PETITION #09-22

60 Charlemont Street and 56 Christina Street

Subject: Northland Charlemont Proposed 40B Development (DRAFT)

**NORTHLAND
160 CHARLEMONT STREET
URBAN DESIGN REVIEW**

Northland and Current 160 Plan

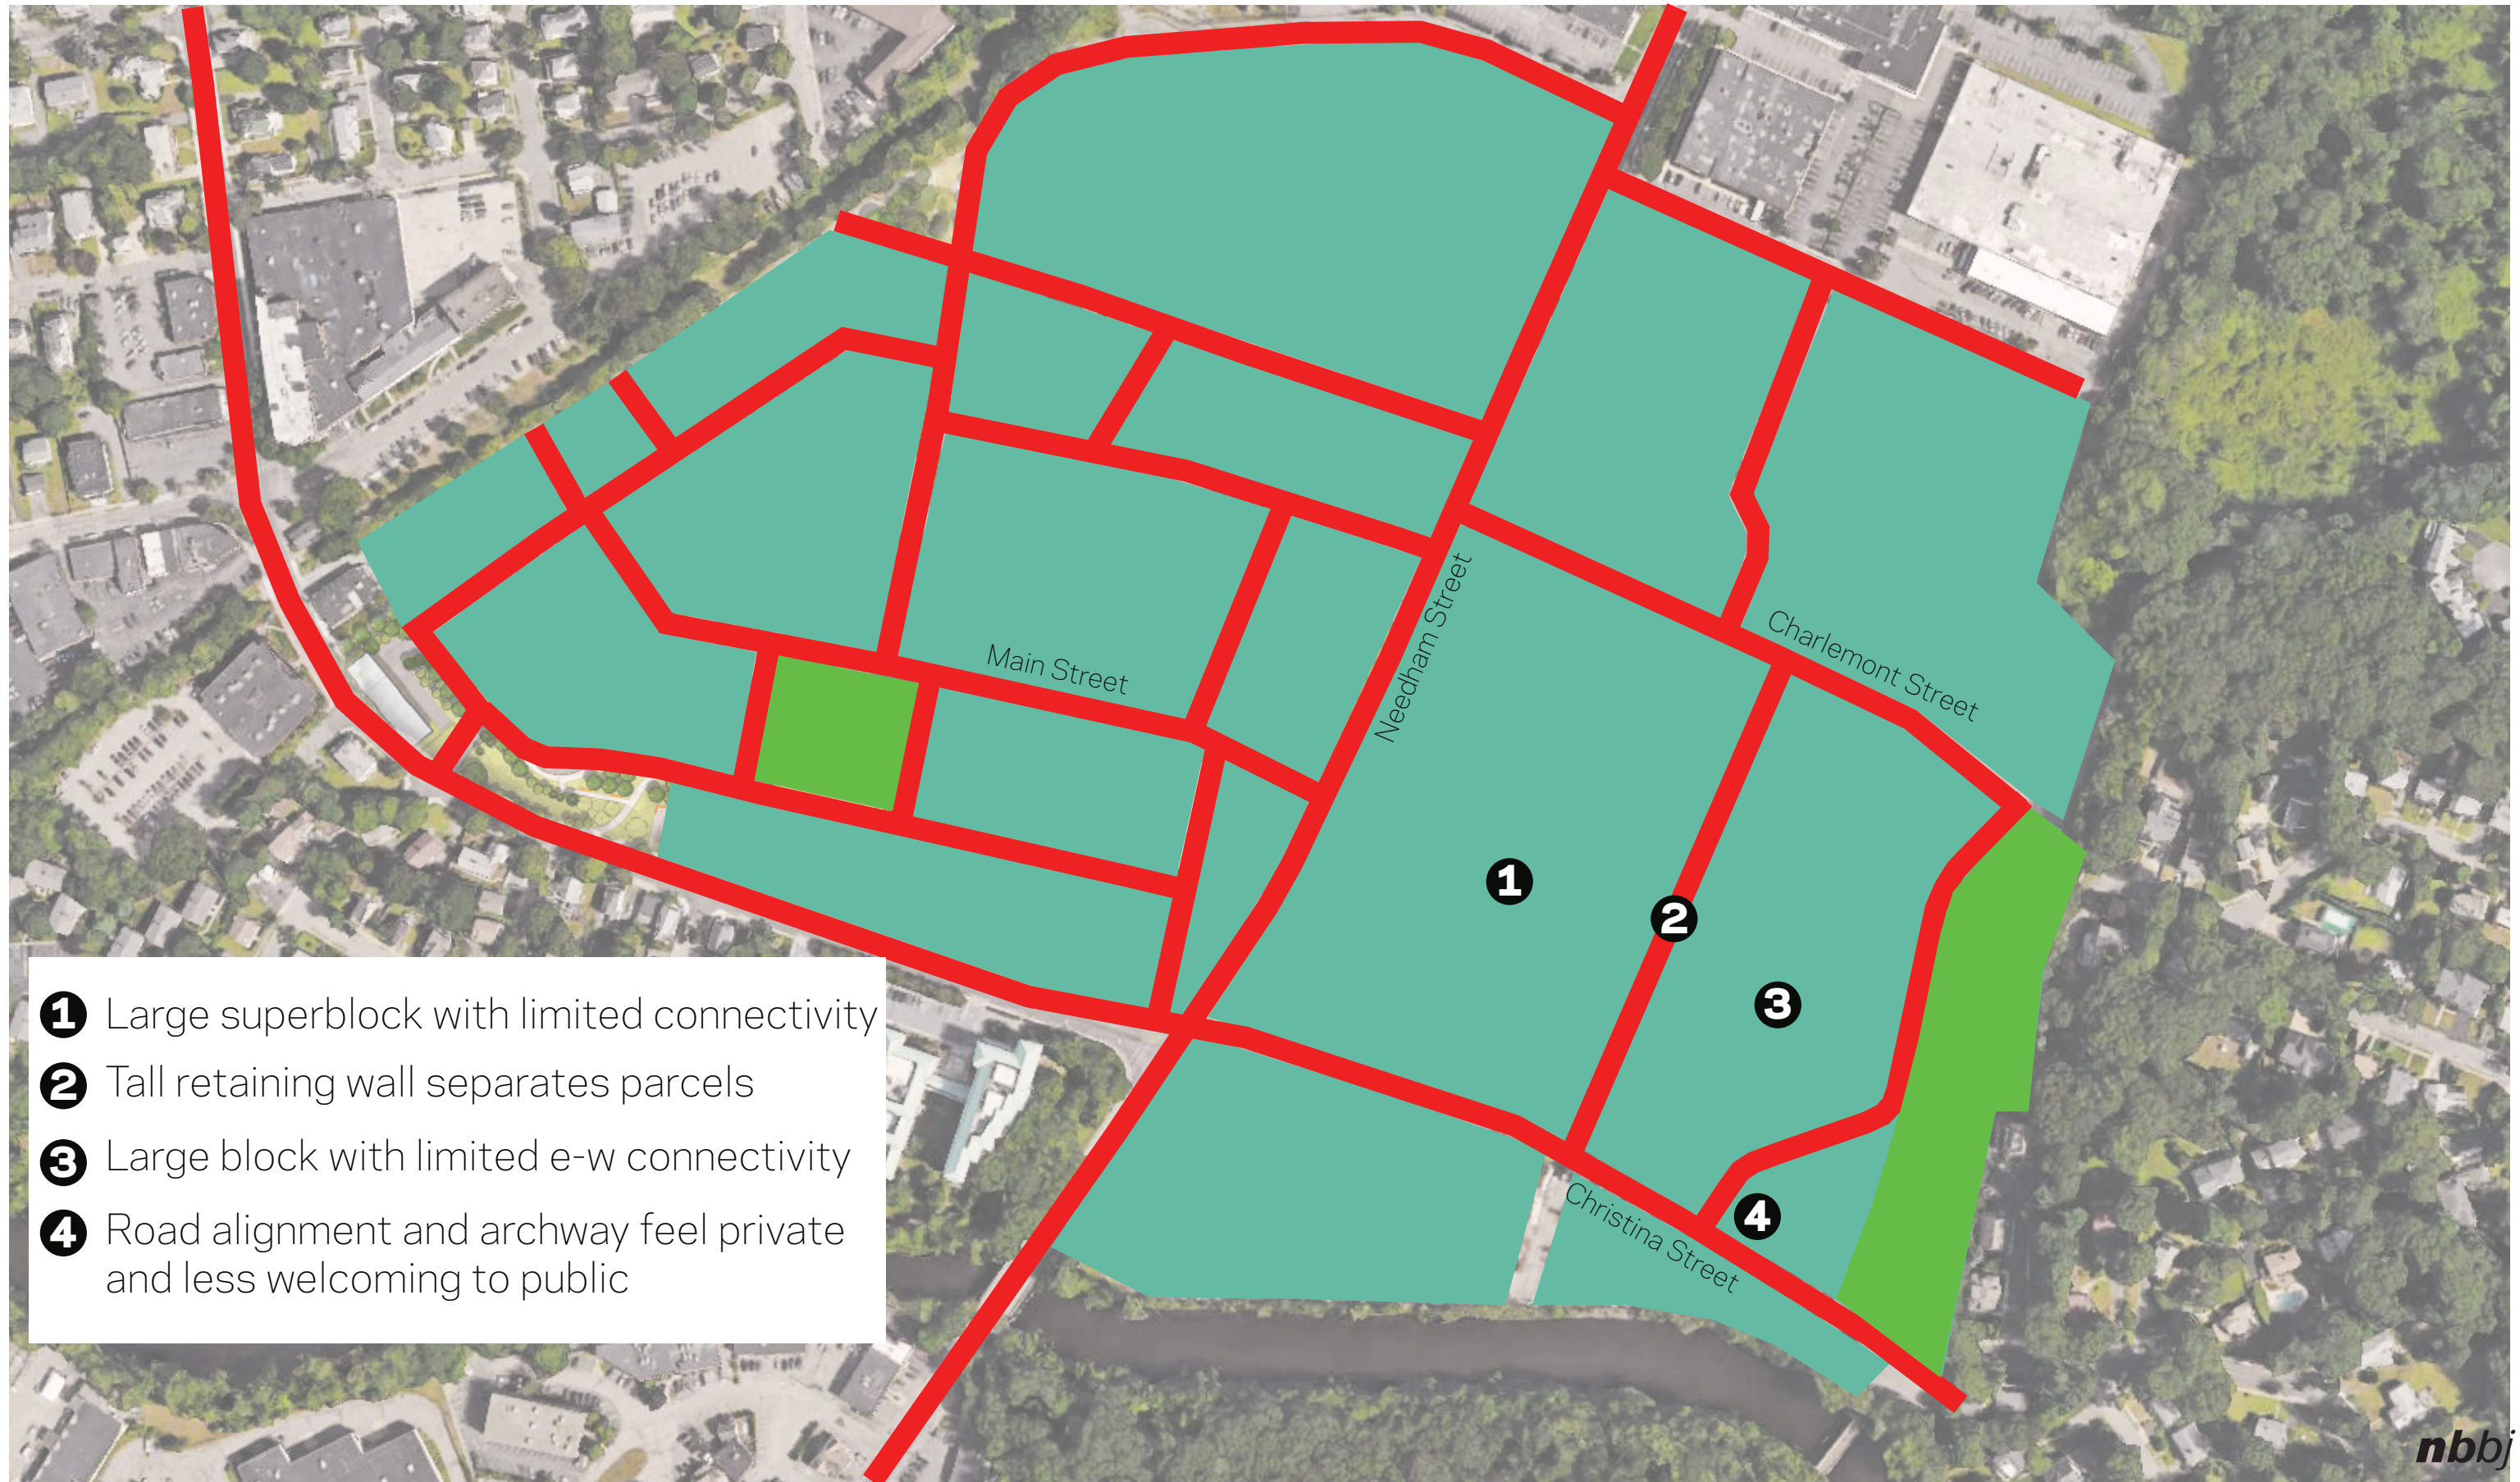
- 1** Large superblock with limited connectivity
- 2** Tall retaining wall separates parcels
- 3** Large block with limited e-w connectivity
- 4** Road alignment and archway feel private and less welcoming to public

- ❶ Potential extension of Main Street
- ❷ Regrade alley to eliminate retaining wall
- ❸ Extend street to create multiple blocks
- ❹ Realign Park Drive to follow park edge

Block Size Comparison

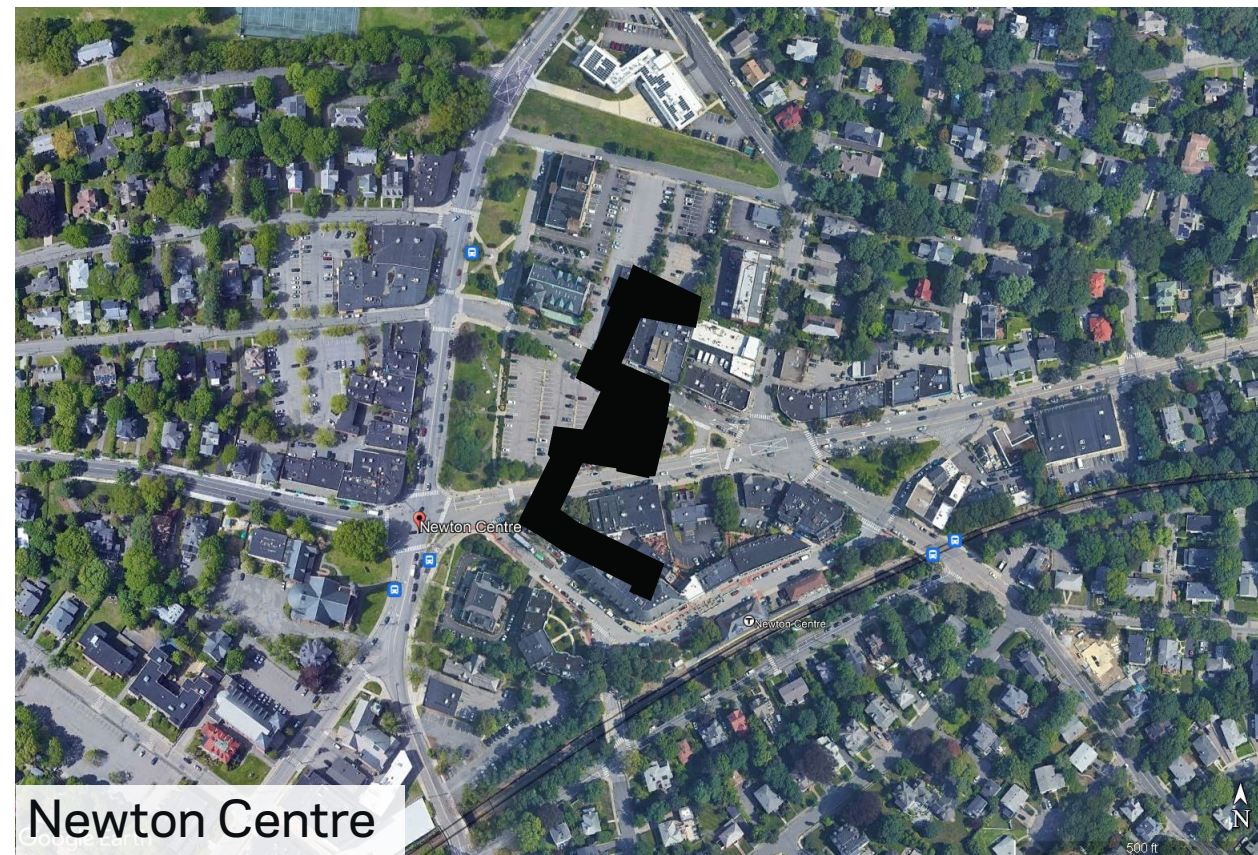
According to the Needham Street Vision Plan, this area scores poorly on two walkability metrics: intersection density and small block sizes (less than $\frac{1}{4}$ mile perimeter or 1,320'). The current proposal has a single block with a 1,810' perimeter that exceeds the maximum by nearly 500'. An alternative two-block approach (shown on the right) could have two separate blocks with a perimeter between 1,076' and 1,120'.

160 Charlemont

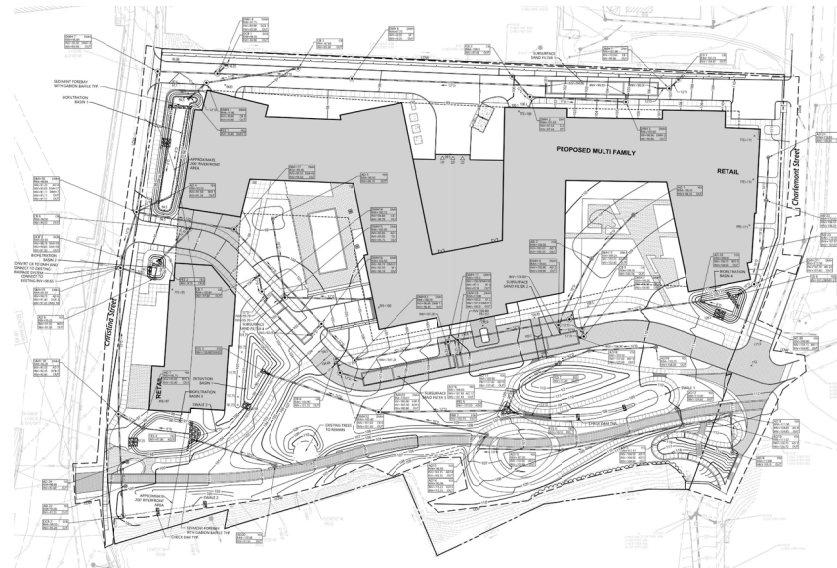
The block sizes and maximum building length for the proposed 160 Charleton project greatly exceed recently approved projects in the surrounding area.

Building Length: 605'
 Total Units: 410
 Parking Spaces: 486 (1.2 per unit)

Charlemont Street

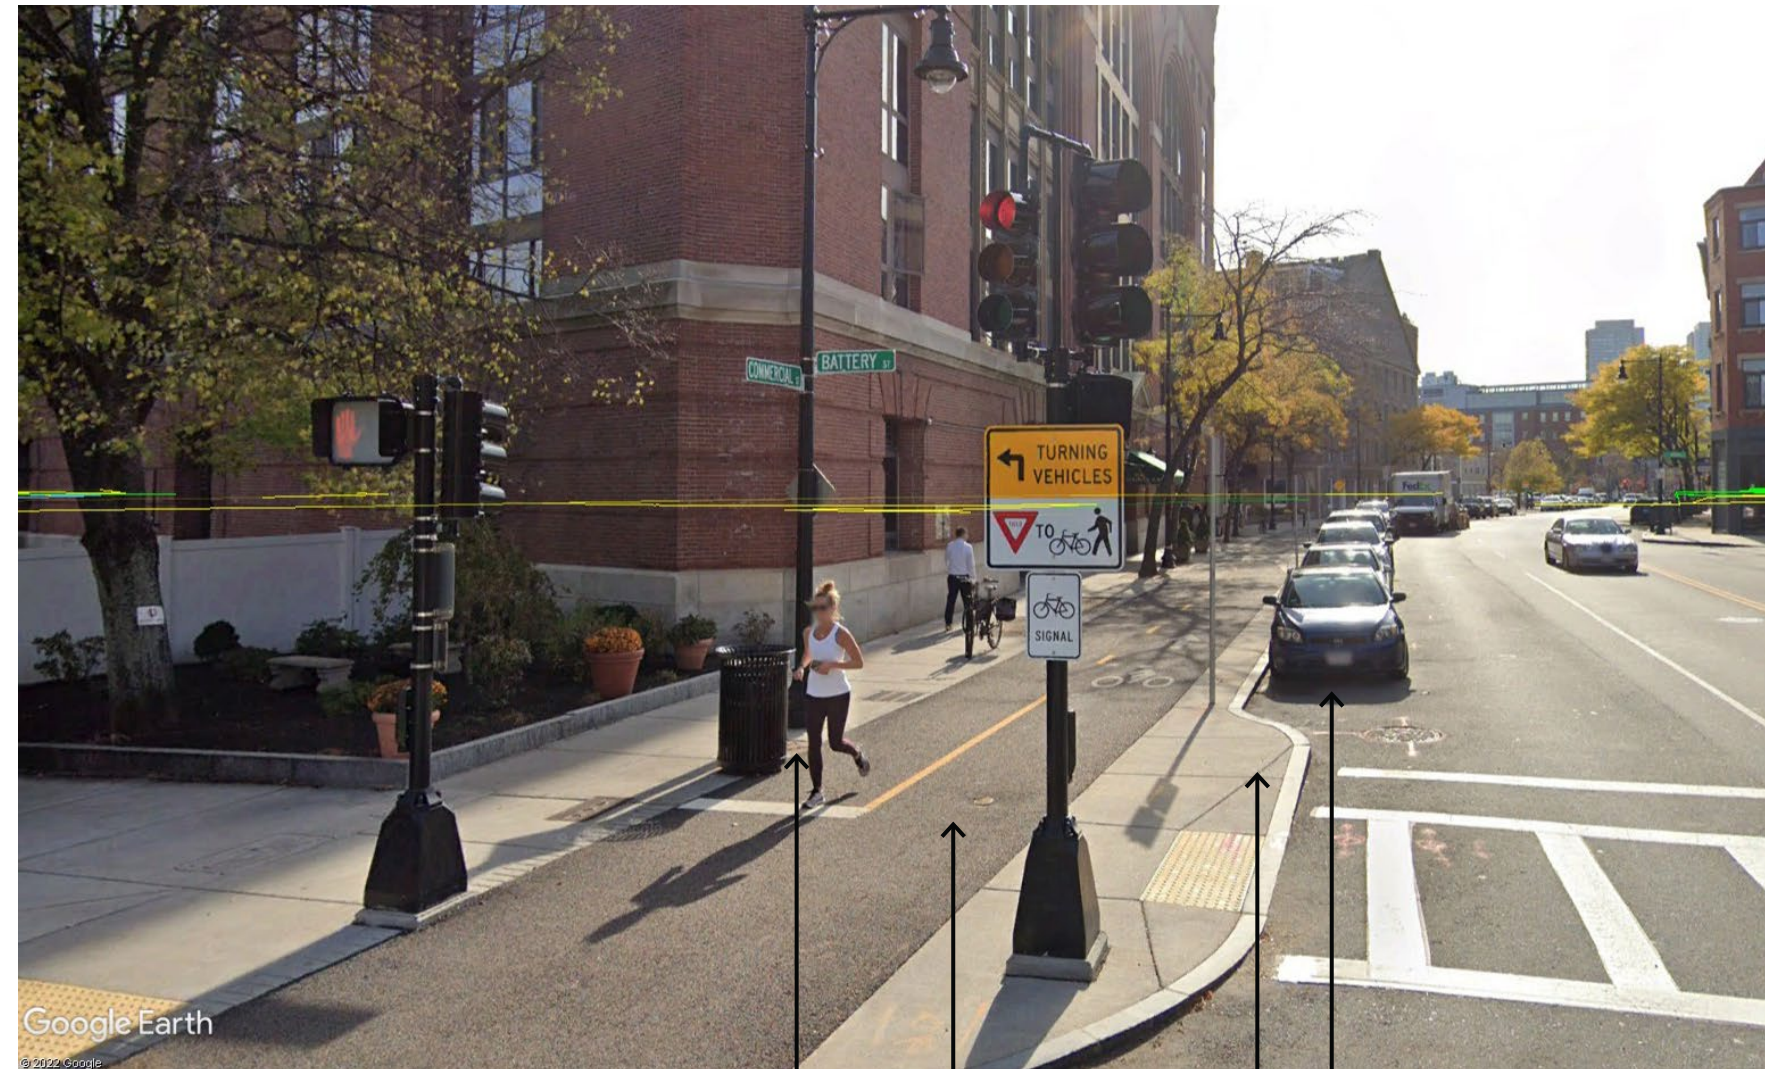
The current conditions for Charlemont Street include a narrow sidewalk on the south side, overhead utilities, and a mix of parallel and head-in parking. The applicant has proposed a limited 6' sidewalk on the south side of the street along with a marked bicycle sharrow that could have significant safety conflicts with the existing head-in parking on the north side of the street. We suggest that the applicant consider a 10' wide separated multi-use path on the south side of Charlemont (see example below), tree planting on both sides of the street to buffer pedestrians from automobiles, the burial of all site utilities, and the installation of pedestrian scaled lighting. These improvements would significantly improve safety along Charlemont and would be consistent with the proposed improvements for the Newton Northland Development on the other side of Needham Street.

Potential Parking Conflict w/ Sharrow and no sidewalk on north side of street
